FIRST DRAFT MINUTES

September 20, 2012 Standards Committee Meeting

RE: Minutes from the September 20, 2012 Standards Committee Meeting

SPECIFICATION, SPECIAL PROVISIONS AND DRAWINGS
REVISION TO STANDARD DRAWINGS

REVISED STANDARD DRAWING 805-SGSP-04 BASE PLATE FOR SIGNAL STEEL STRAIN POLE (DRAFT)

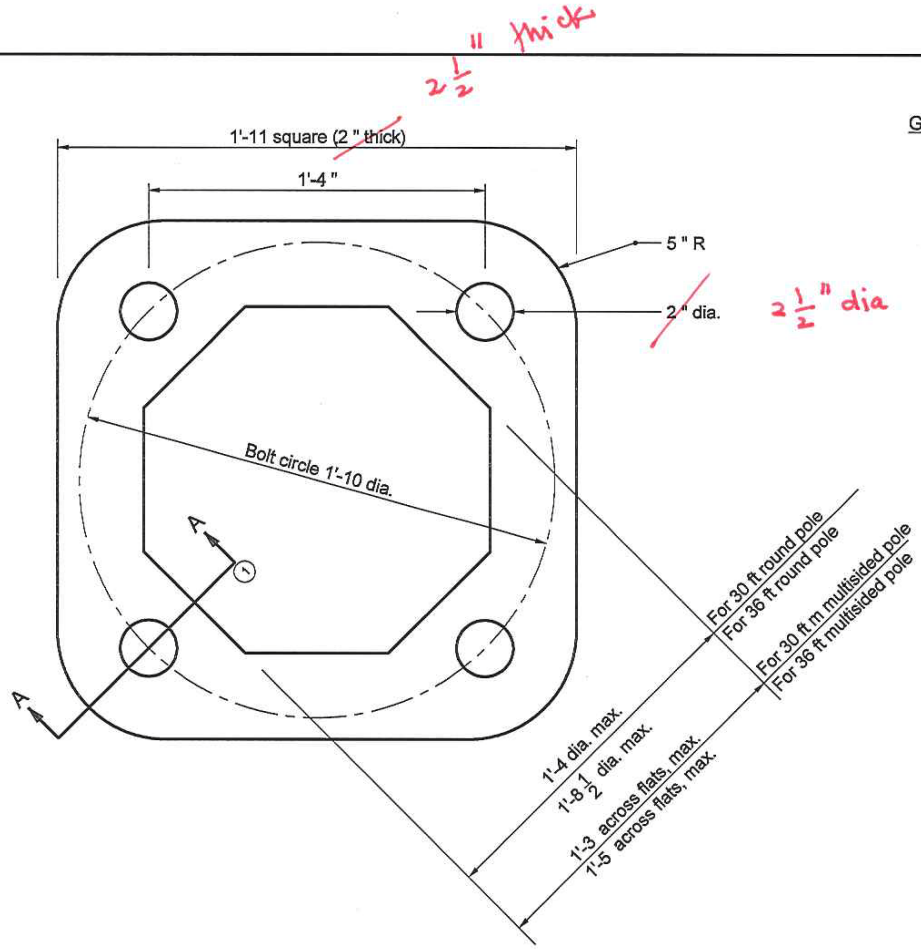
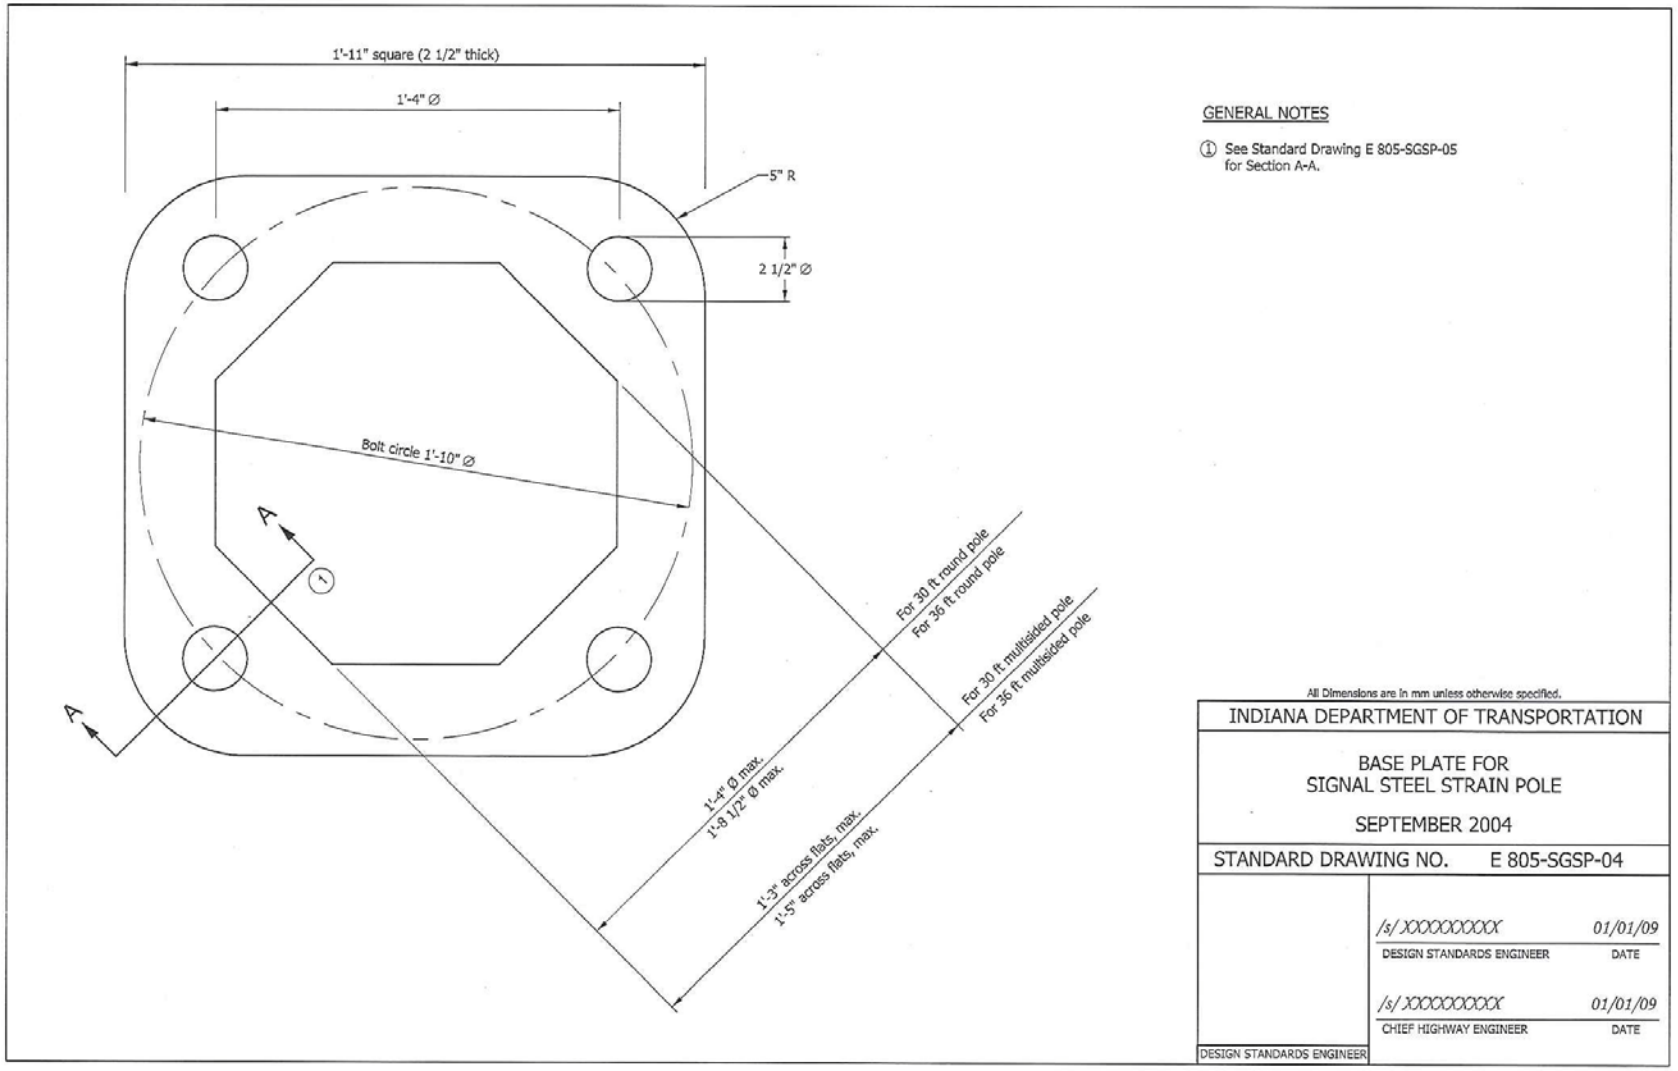
3. Standard Drawing 805-SGSP-04 for signal strain poles contains incorrect dimensions for the base plate thickness and anchor bolt hole diameter.

Mr. Boruff continued explaining the rest of the revisions presented. Ms. Phillips asked about the bolt circle and Mr. Boruff stated that it is correct and that it is centered.

3. Revise Standard drawing 805-SGSP-04 by correcting the anchor bolt hole diameter to 2 1/2" (currently shown as 2") and the base plate thickness to 2 1/2" (also currently shown as 2").

EXISTING 706-TTFC-01 CONCRETE BRIDGE RAILING TRANSITION TFC PLAN AND ELEVATION (WITH MARKUPS)

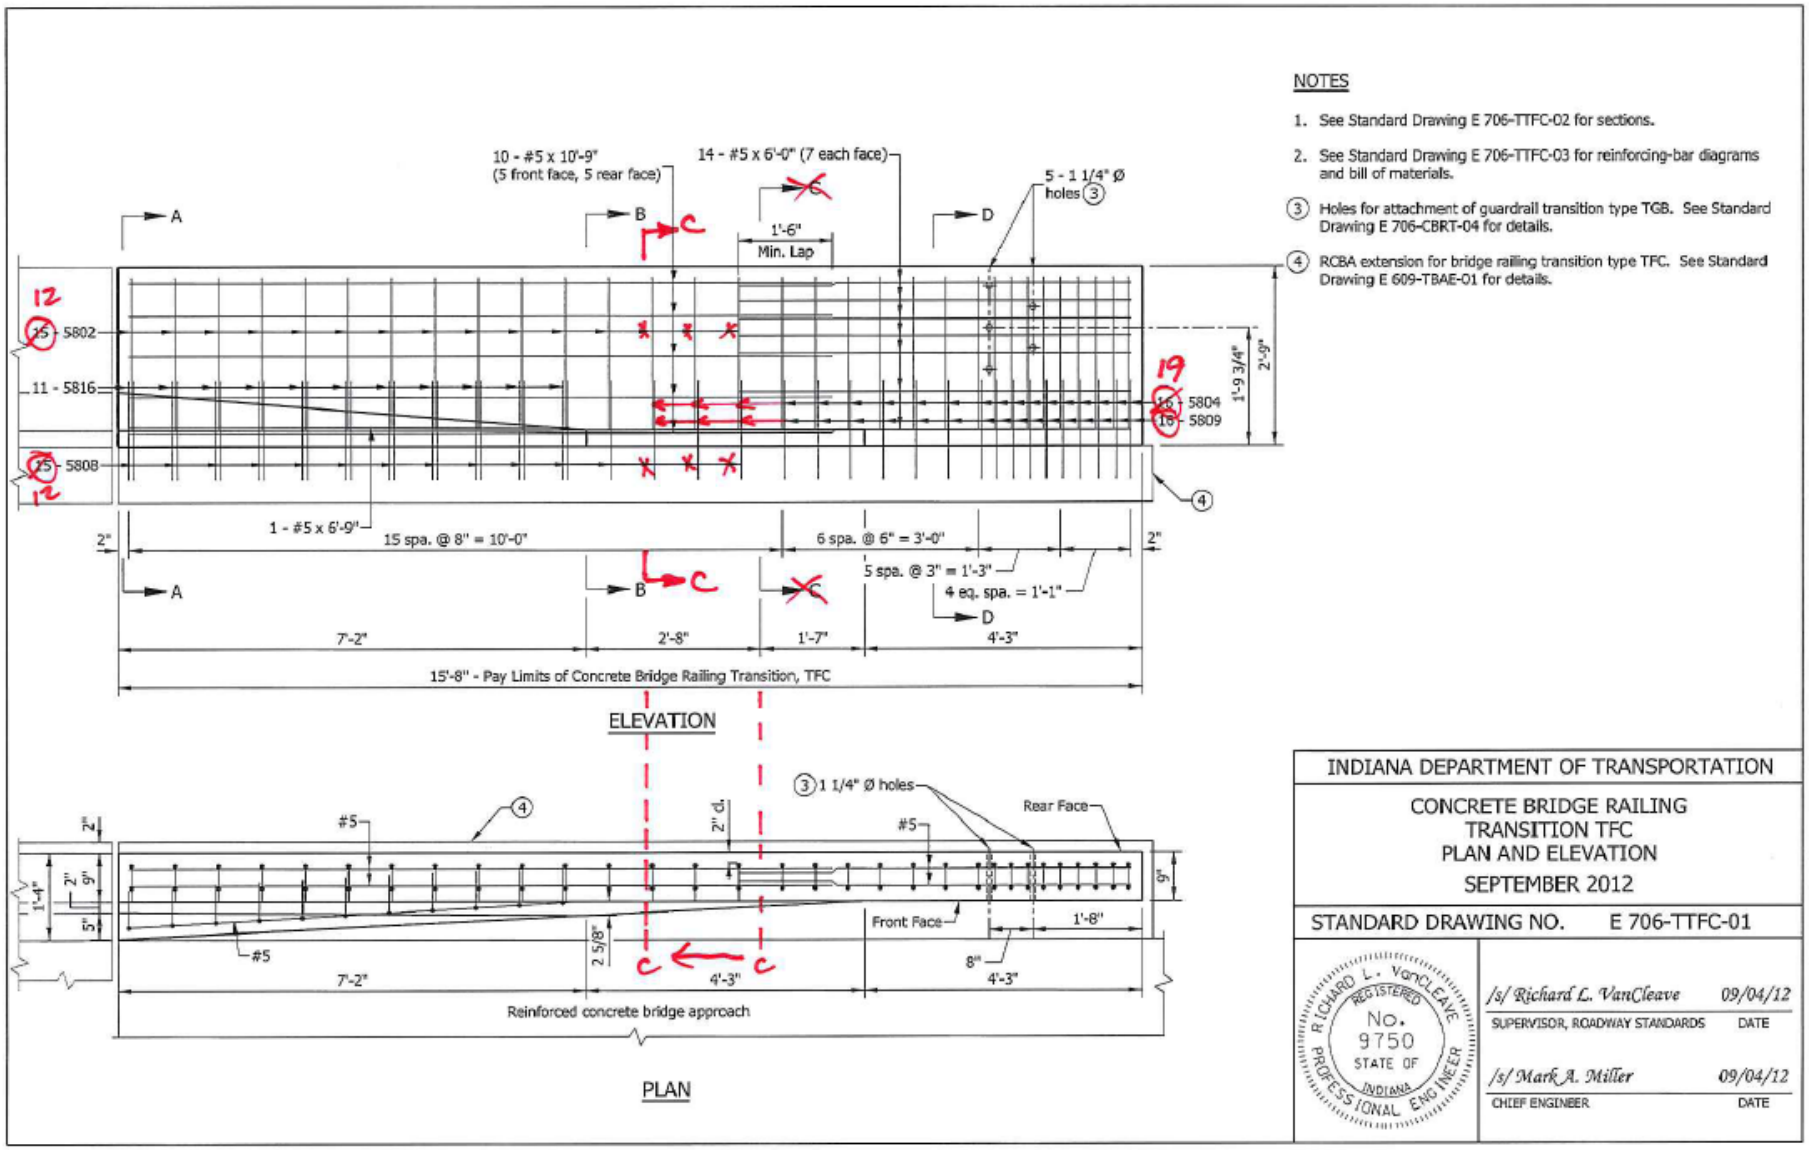
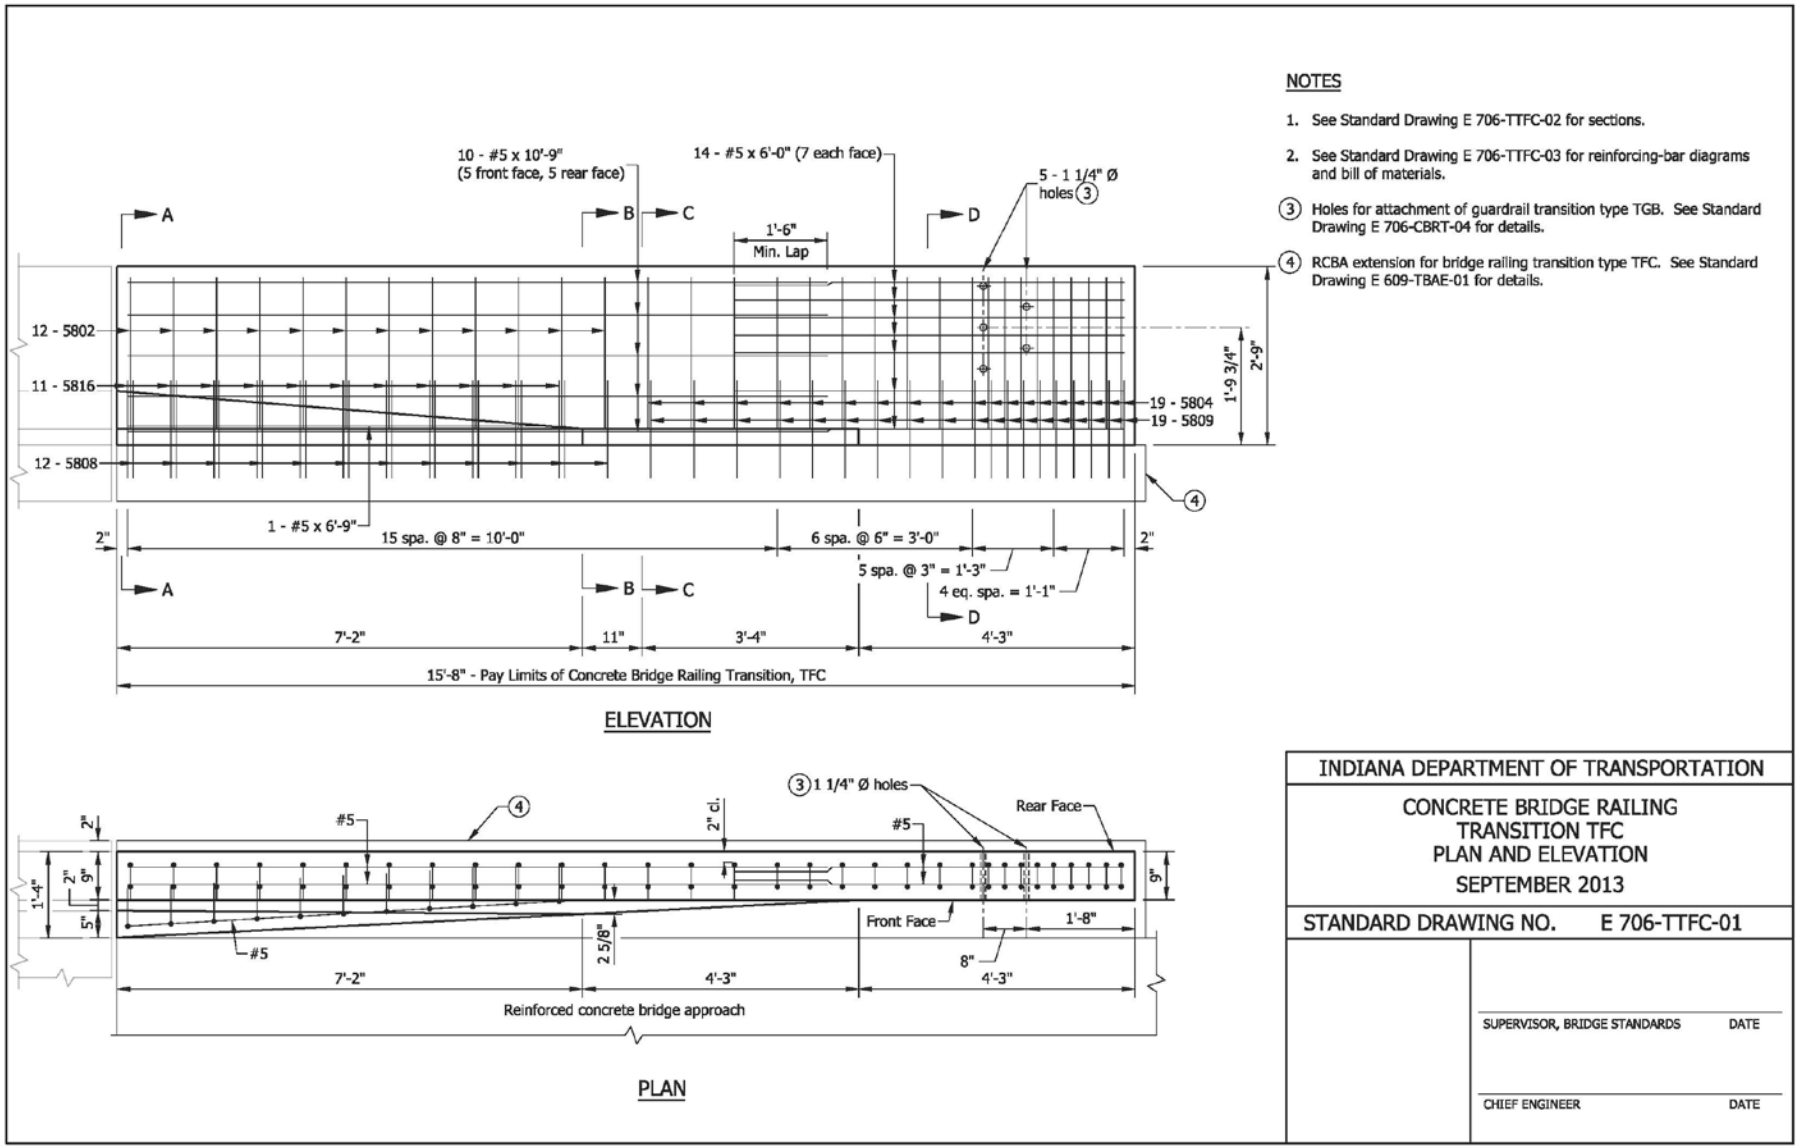
PROBLEM(S) ENCOUNTERED: A review of Standard Drawing 706-TTFC-01 through -03 revealed an error in the location of a section and consequently, an incorrect bill of materials.

PROPOSED SOLUTION: Revise the drawings to show the correct location of the section and quantities in the bill of materials. See attached markups and final drafts of proposed revised drawings.

706-TTFC-02 CONCRETE BRIDGE RAILING TRANSITION, TFC SECTIONS (DRAFT)

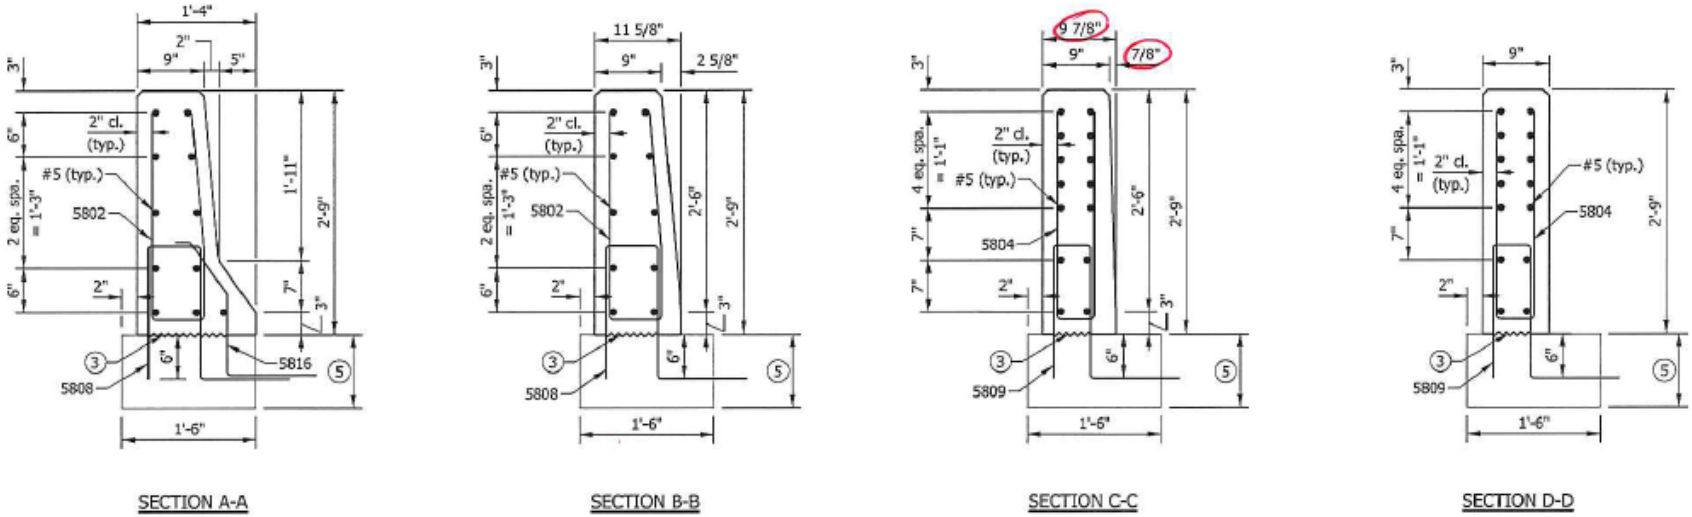
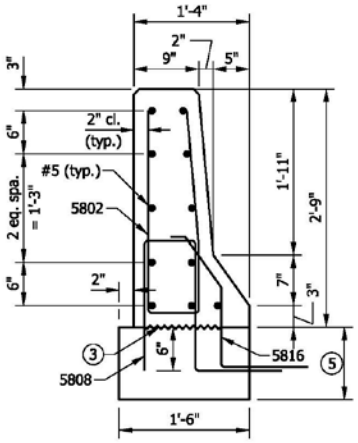
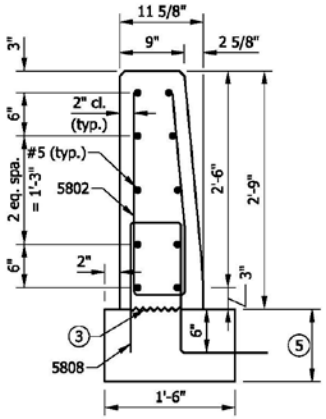
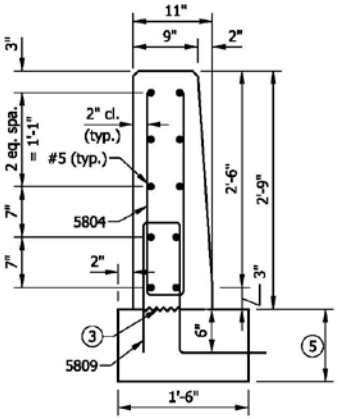
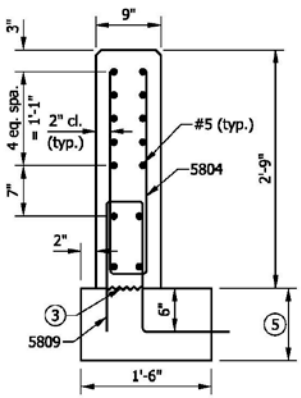
DISCUSSION: Ms. Phillips presented this item as shown and as described in the proposal page, and made a motion that this item be approved as submitted. Mr. Cales seconded that motion. Ms. Phillips then explained the revisions as shown attached above, and how the bill of materials is affected. A minor revision was recommended for section C-C, that the longitudinal bars should not be shown. Ms. Phillips will have that corrected.
